ATTACHMENT 2

D3C10 Evaluation of Significant Hazards Consideration

Commonwealth Edison proposes to amend Facility Operating License DPR-25 for Dresden Unit 3 to allow the use of Exxon 9x9 fuel, operation of the reactor in an expanded POWER/FLOW region and allow Single Loop Operation above 50% thermal power for Cycle 10.

FIGURE 3.6.2

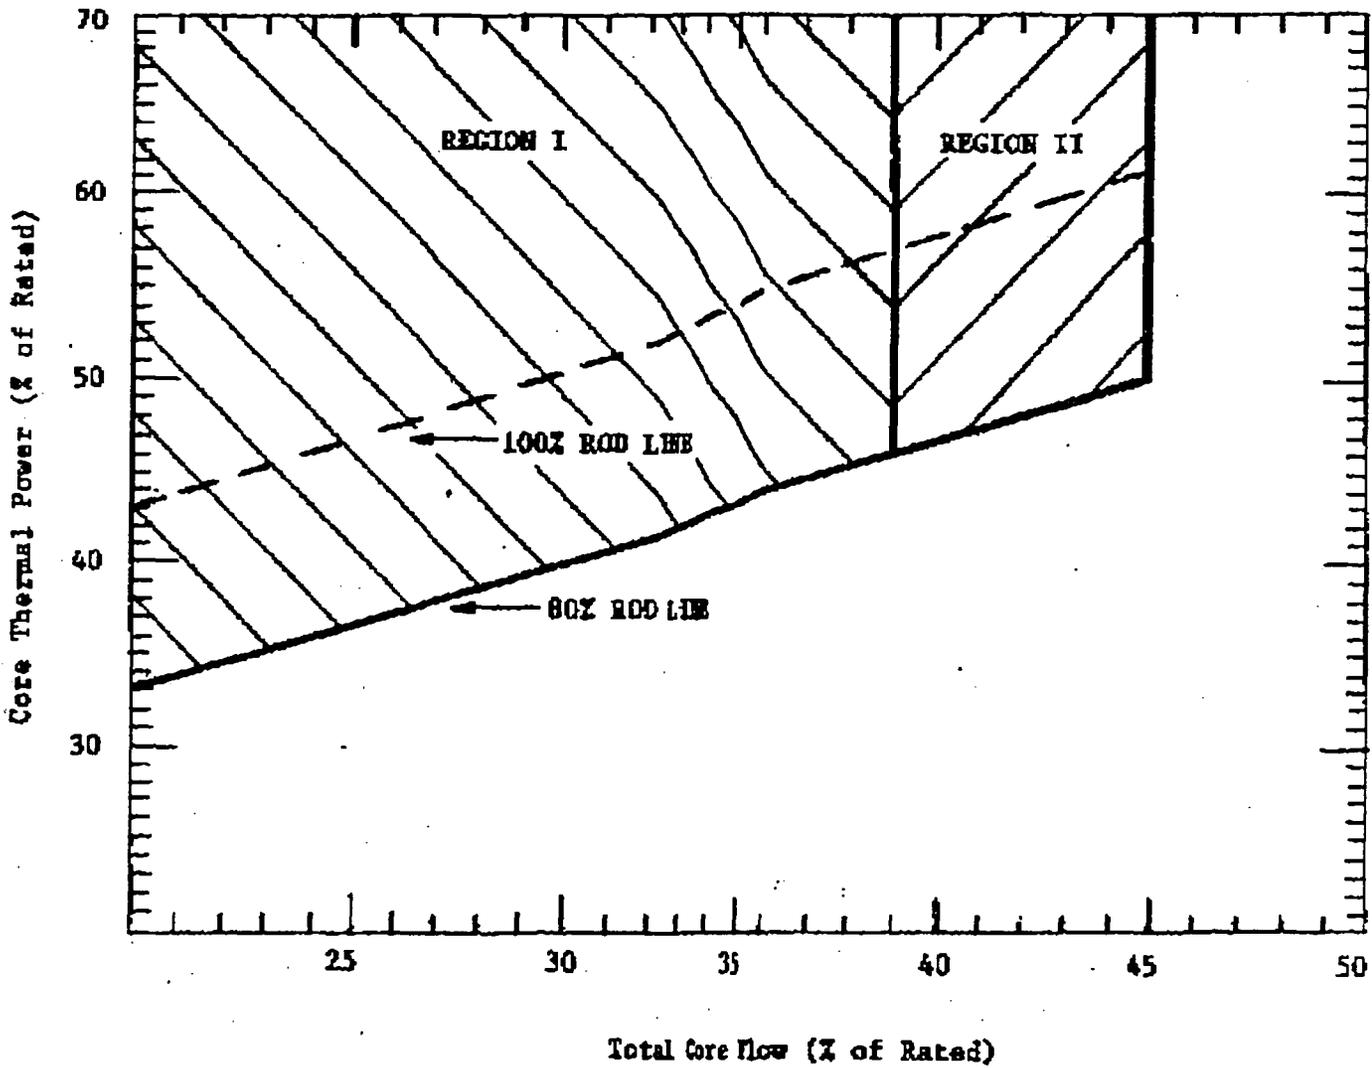
3. During Single Loop Operation, the following restrictions are required:
- a. Operation with the Master Flow Control in AUTO is not permitted;
 - b. Operation in Region I of Figure 3.6-2 is not permitted. Initiate action immediately after entering Region I and be outside of Region I within 2 hours.

- 3.a. Baseline APRM and LPRM* noise levels for SLO shall be acquired prior to entering Region II of Figure 3.6-2 for the first time following each refueling outage.
- b. When operating in Region II of Figure 3.6-2 perform APRM and LPRM* surveillances to verify that their noise levels are within three (3) times their established baseline values at the following intervals:
- i. Within 30 minutes of entering Region II;
 - ii. At least once per 8 hour shift; and
 - iii. Within 30 minutes after the completion of a core thermal power increase of 5% or greater.
- * Detector levels A and C of one LPRM string per core octant plus detector levels A and C of one LPRM string in the center of the core shall be monitored.

- c. Operation in Region II of Figure 3.6-2 is permitted provided that:
 - i. Baseline data has been acquired per specification 4.6.H.3.a;
 - ii. If baseline data has not been acquired per specification 4.6.H.3.a., immediately initiate action to be outside Region II within 2 hours;
 - iii. Stable reactor operation is verified per specification 4.6.H.3.b.; and
 - iv. If stable reactor operation cannot be verified per specification 4.6.H.3.b., immediately initiate action to restore stable operation within 2 hours.
- d. The operable recirculation pump shall be at a speed less than 65% of rated before starting the inoperable pump;

Regions I and II of Figure 3.6.2 represent the areas of the power/flow map with the least margin to stable operation. Although calculated decay ratios at the intersection of the natural circulation flow line and the APRM Rod Block line indicate that substantial margin exists to where unstable operation could be expected. Specifications 3.6.H.3.b., 3.6.H.3.c. and 4.6.H.3. provide additional assurance that if unstable operation should occur, it will be detected and corrected in a timely manner.
